PROJECT: GRK Corporate Hangar Phase II
AIP # 3-48-0361-050-2022

Change Order No. 003 makes the following changes, see attached for detailed terms of the change order.

Project:
GRK Corporate Hangar Phase II City of Killeen Bid No. 23-06
Killeen-Fort Hood Regional Airpc FAA AIP No. 3-48-0361-050-2022
Garver Project No. 21A06081

Change Order No. 3

SHEET INDEX

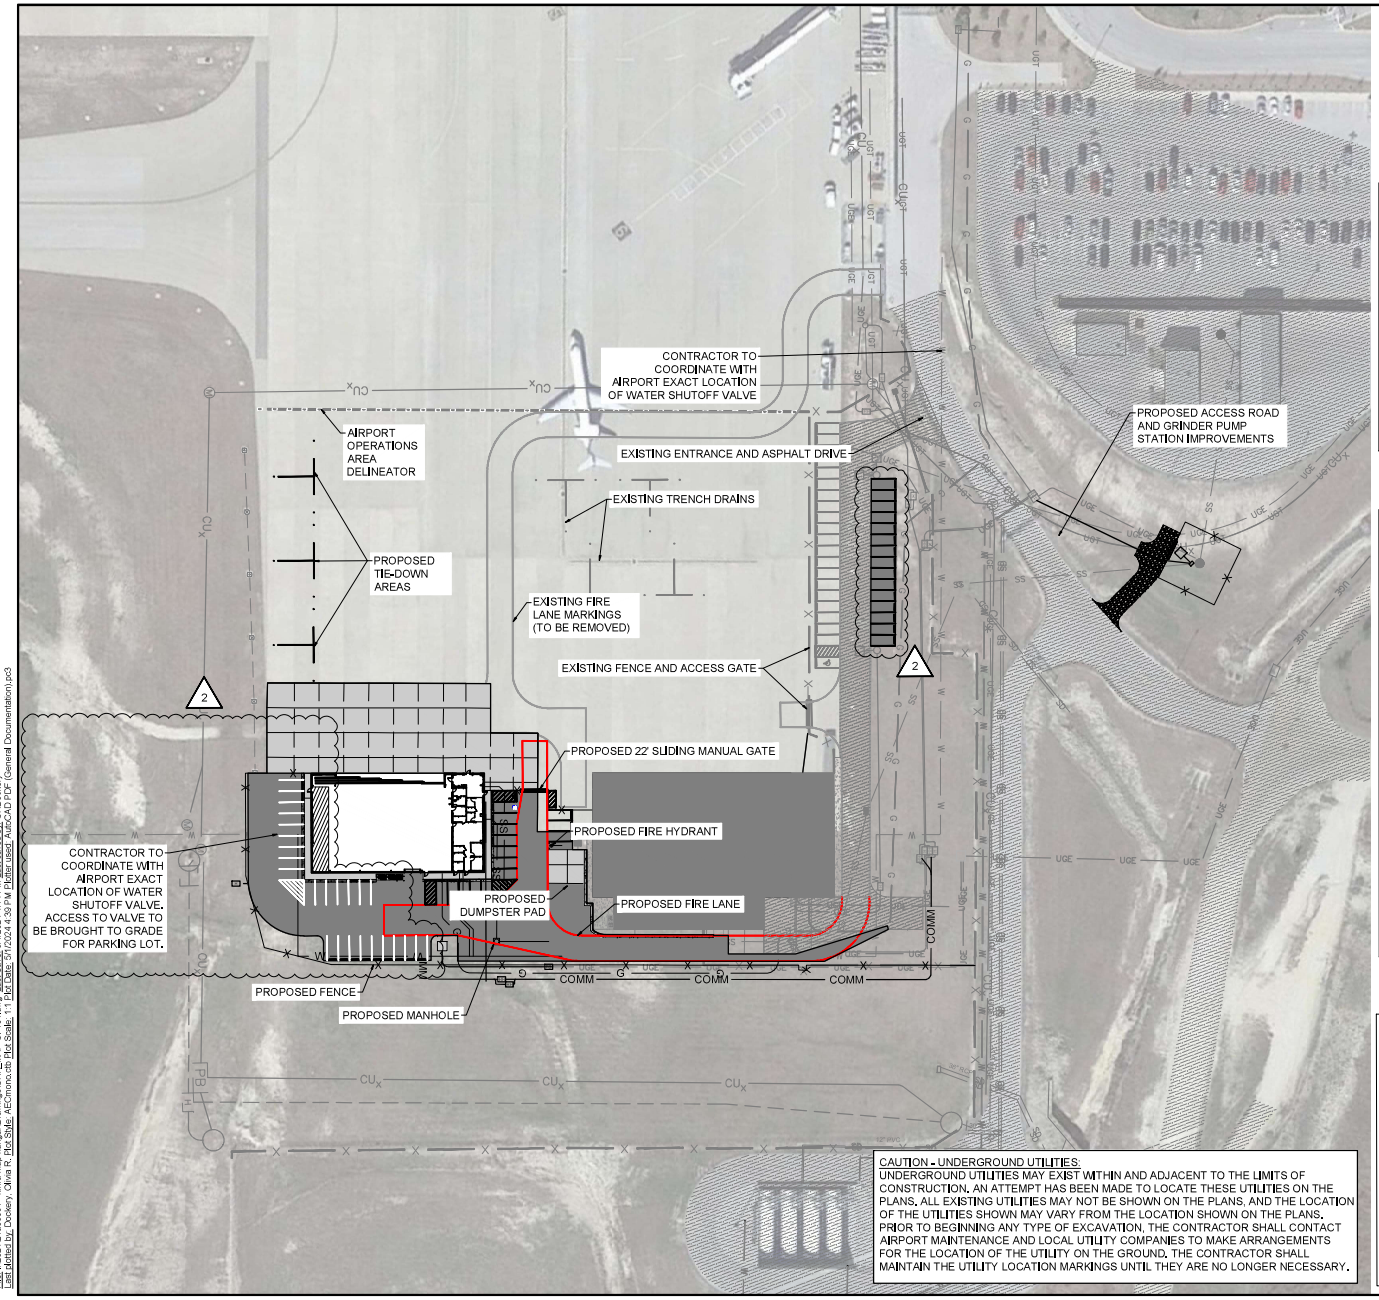
REV.	DATE	DESCRIPTION	BY
-	2/24/23	ISSUED FOR CONSTRUCTION	JCG
1	5/6/24	C.1.0.3 - ADDITIONAL PARKING	JCG

PROJECT LAYOUT PLAN

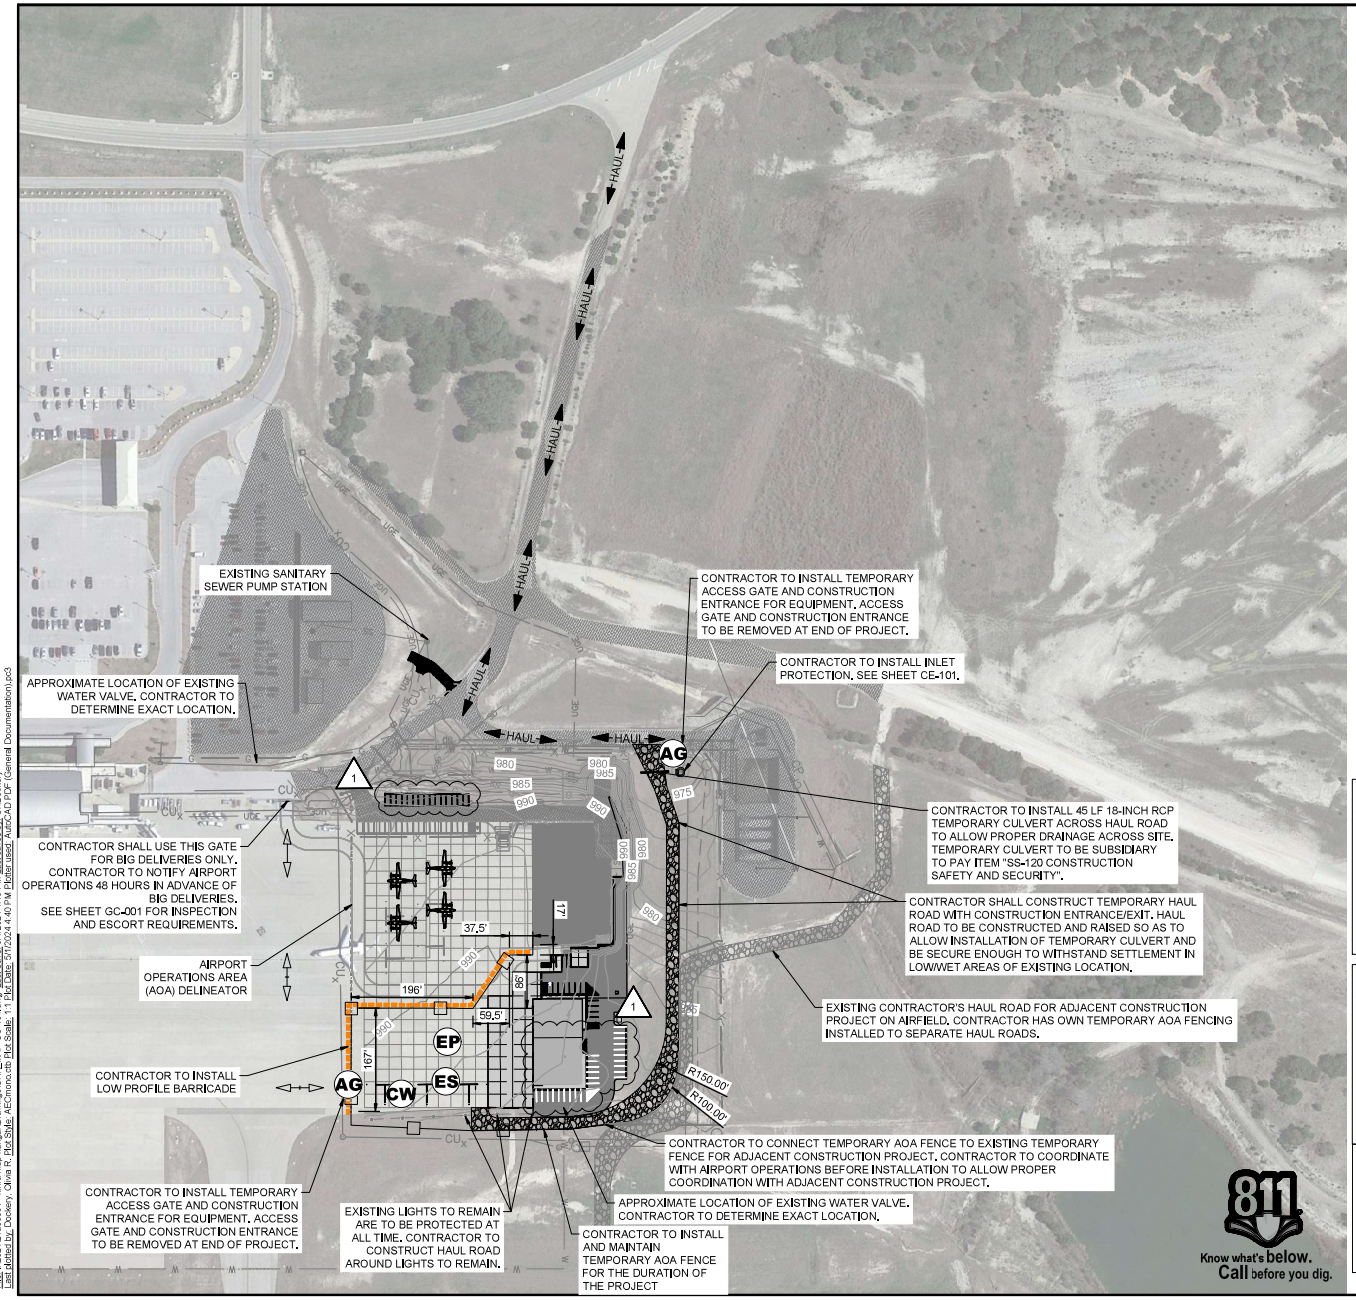
REV.	DATE	DESCRIPTION	BY
-	2/24/23	ISSUED FOR CONSTRUCTION	JCG
1	4/16/24	FIELD DIRECTIVE 2 - ADDITIONAL APRON PAVING	JCG
2	5/6/24	C.0.3 - ADDITIONAL PARKING	JCG

CONSTRUCTION SAFETY AND PHASING PLAN

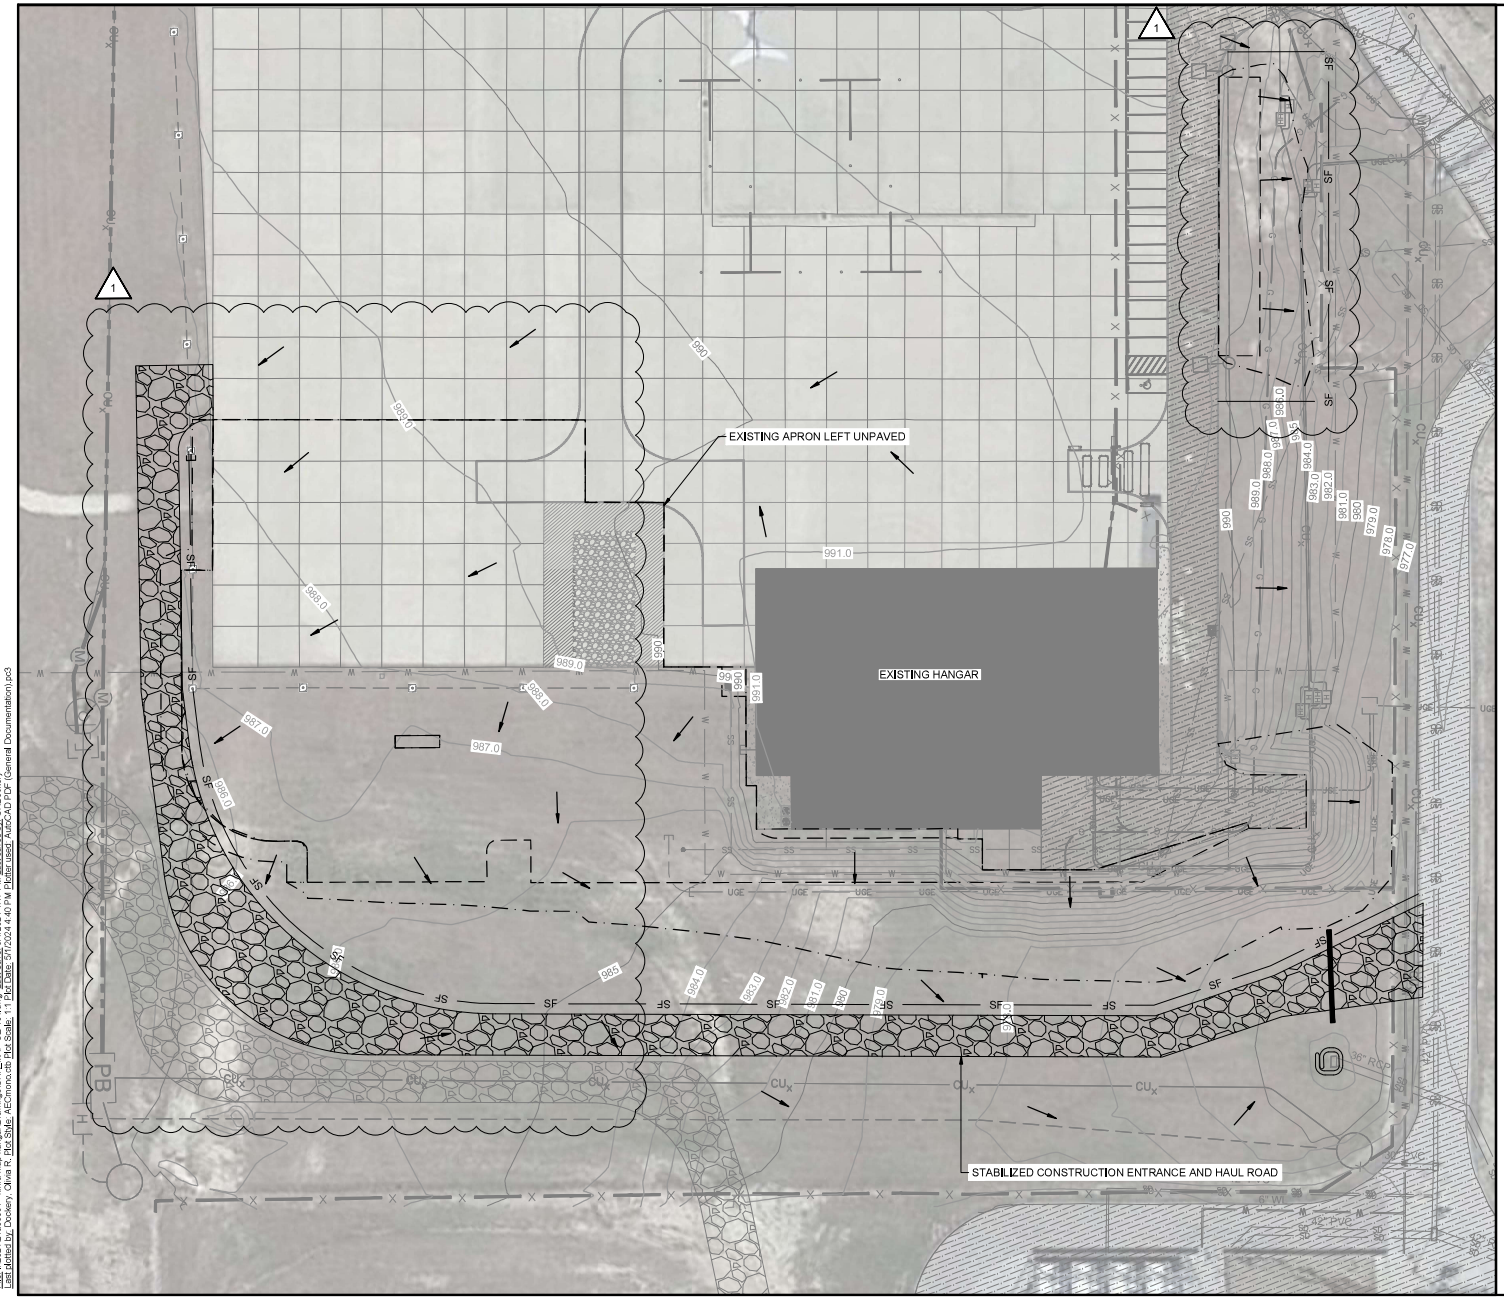
REV.	DATE	DESCRIPTION	BY
-	2/24/23	ISSUED FOR CONSTRUCTION	JCG
1	5/6/24	C.0.3 - ADDITIONAL PARKING	JCG

EROSION CONTROL PLAN

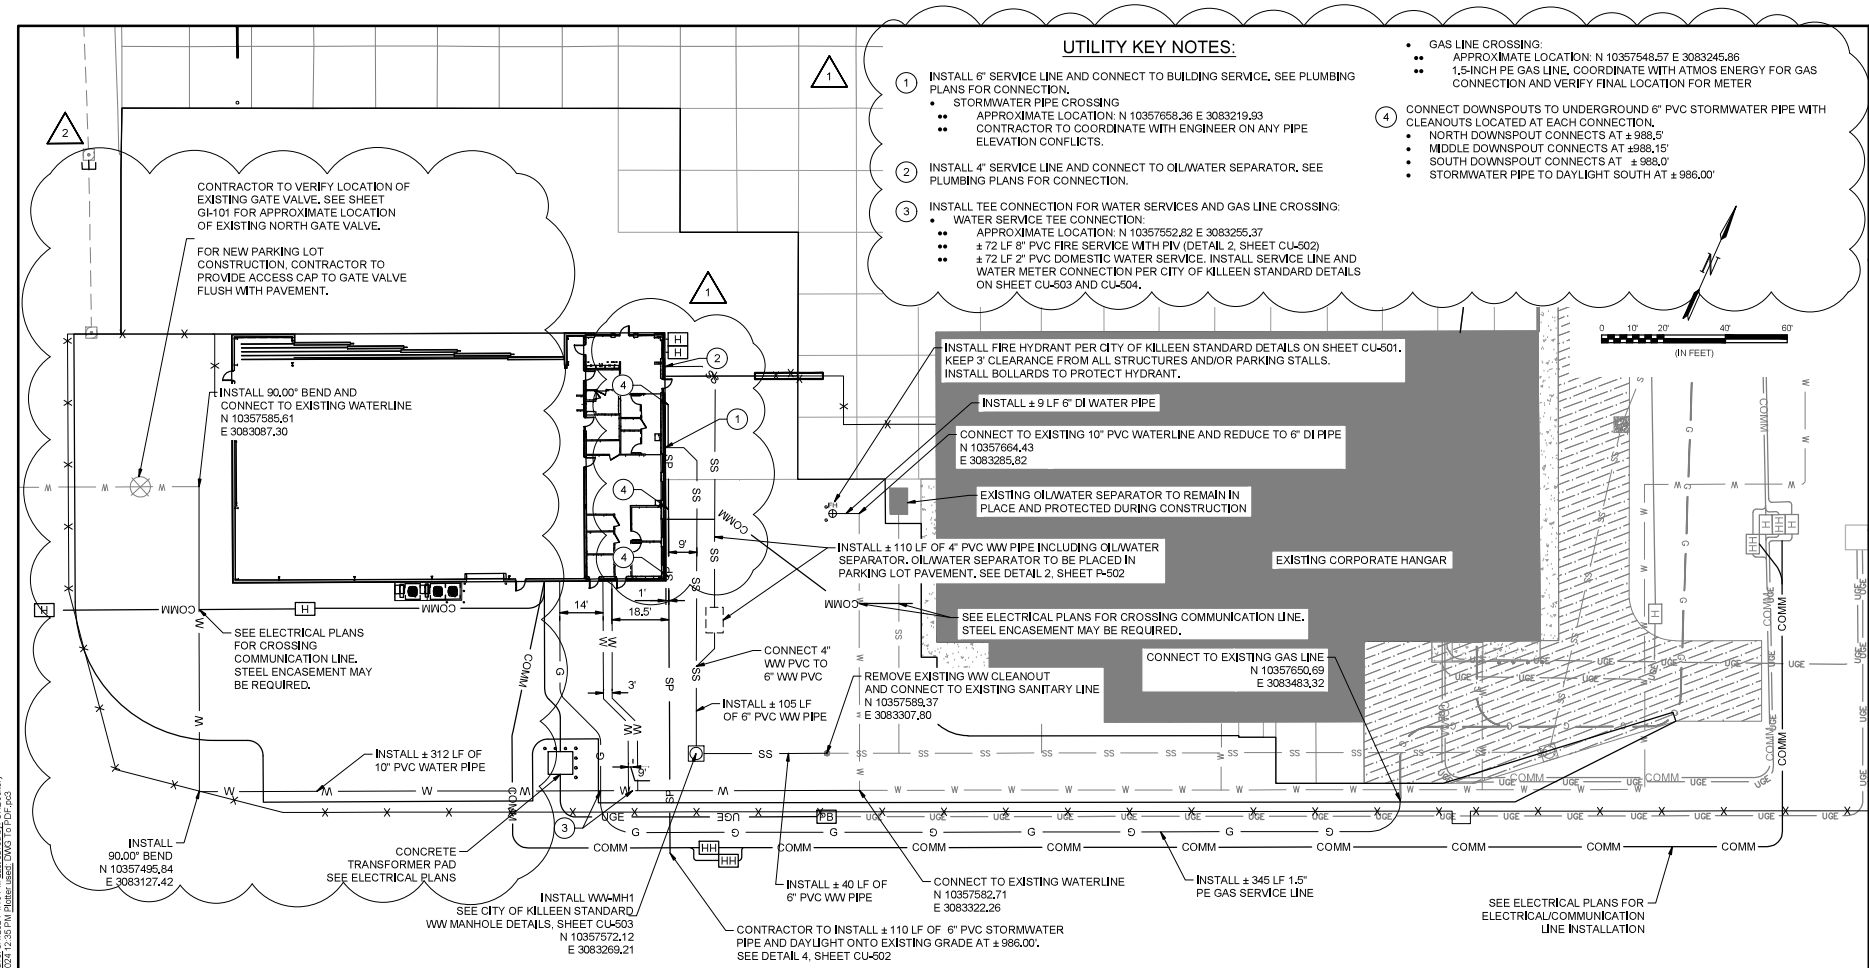
REV.	DATE	DESCRIPTION	BY
-	2/24/23	ISSUED FOR CONSTRUCTION	JCG
1	5/6/24	C.1.0.3 - ADDITIONAL PARKING	JCG

SITE LAYOUT PLAN

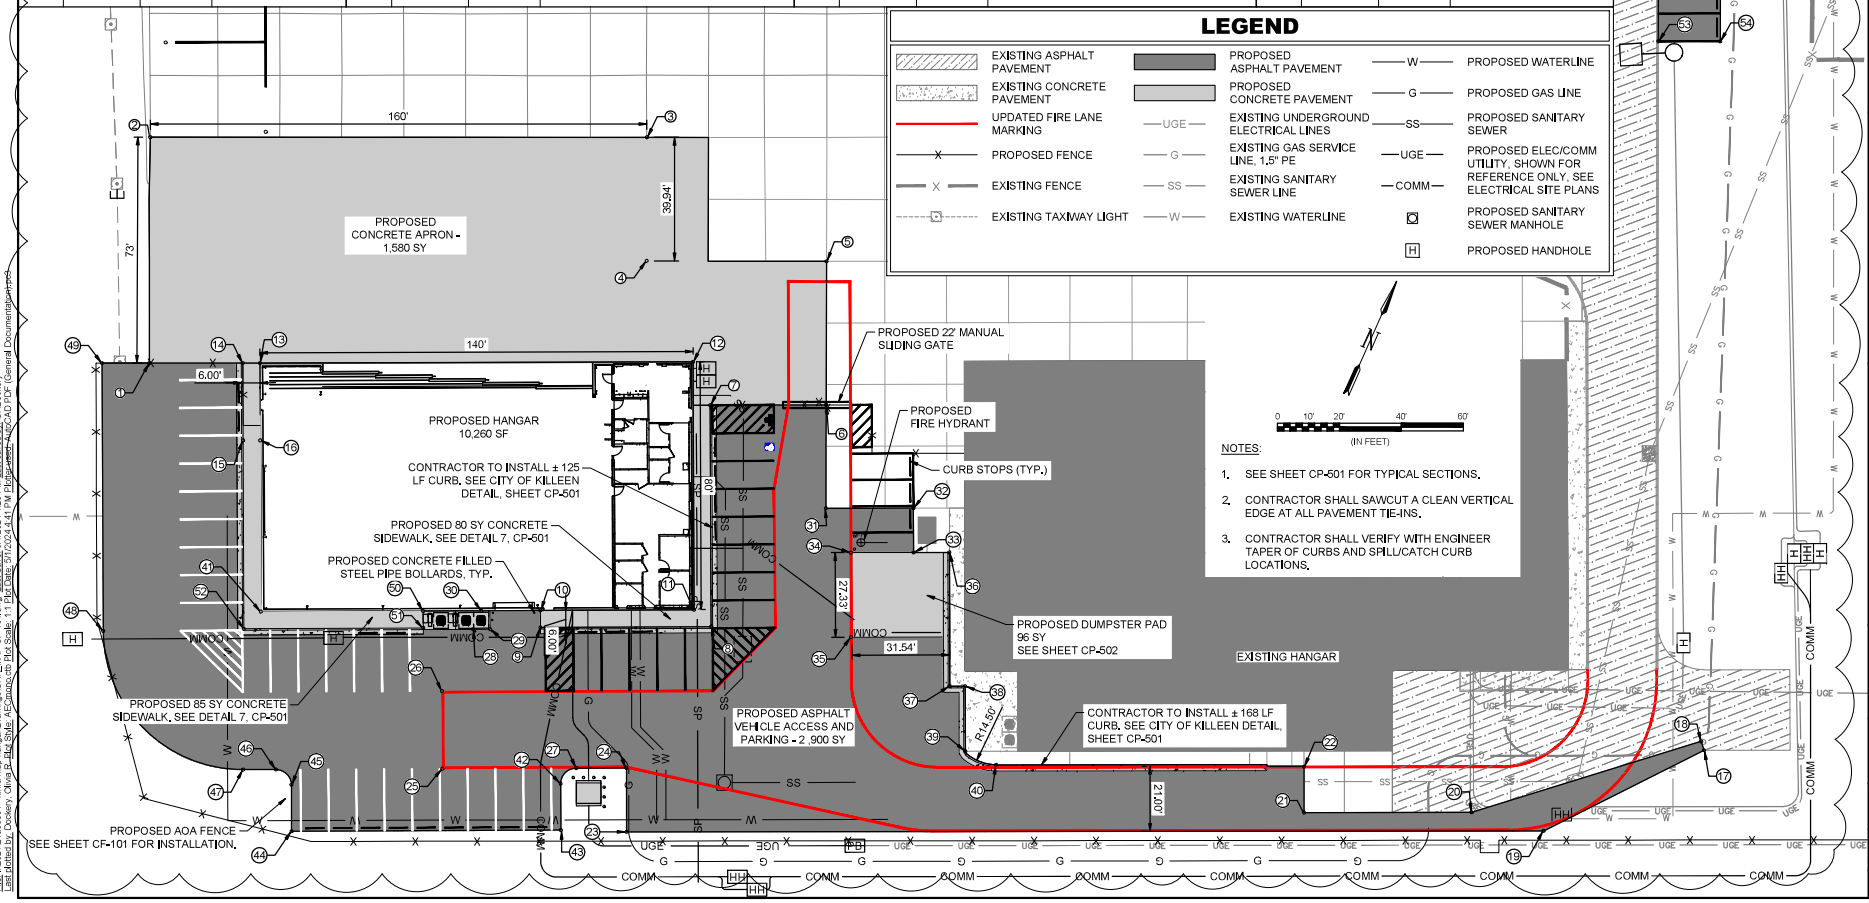
A. Change includes increasing parking area necessary to support the functions of the building based on Owner input. Contractor shall construct the additional parking area per the attached Drawings. Note, engineer may provide contractor with revised and finalized design sheets. Contractor shall notify engineer a minimum of 4 weeks prior to affected work to allow engineer a minimum of 2 weeks to provide finalized drawings ahead of Contractor layout/staking.

REV.	DATE	DESCRIPTION	BY
-	2/24/23	ISSUED FOR CONSTRUCTION	JCG
1	5/6/24	C.1.0.3 - ADDITIONAL PARKING	JCG

SITE GRADING PLAN

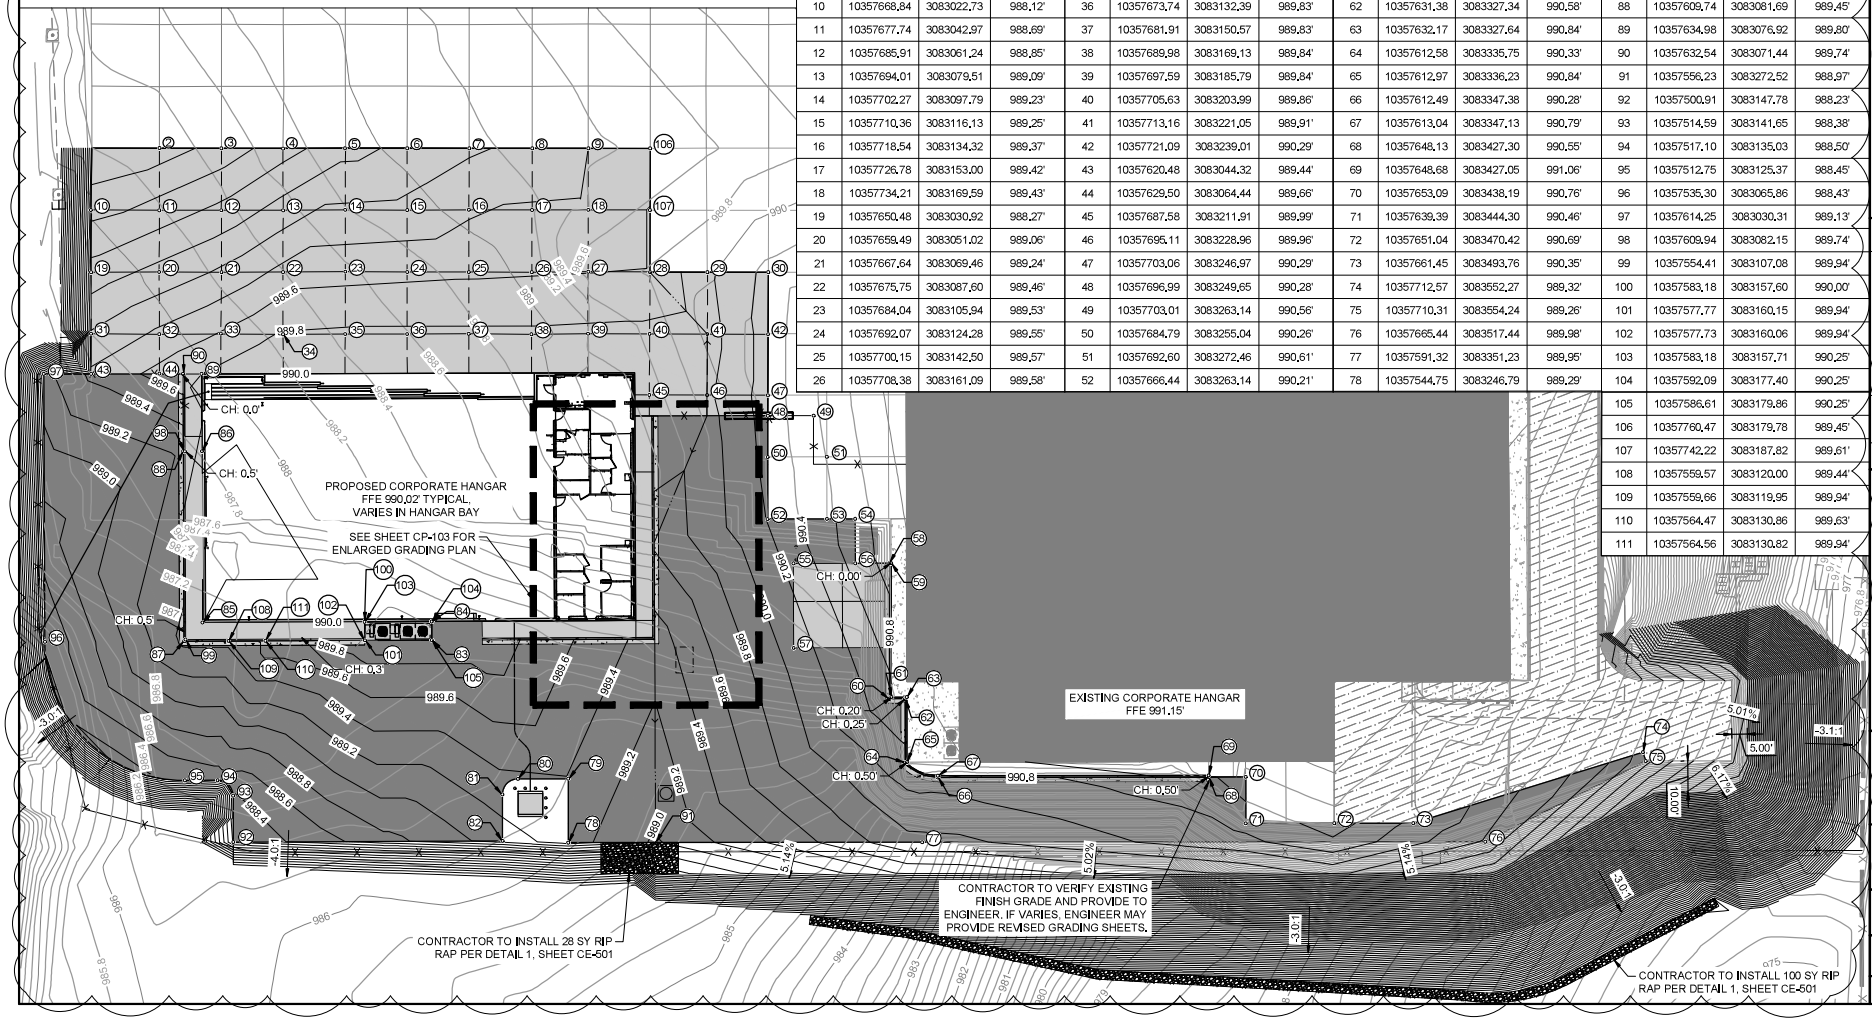
REV.	DATE	DESCRIPTION	BY
-	2/24/23	ISSUED FOR CONSTRUCTION	JCG
1	4/15/24	FIELD DIRECTIVE #2	JCG
2	5/6/24	C.03 - ADDITIONAL PARKING	JCG
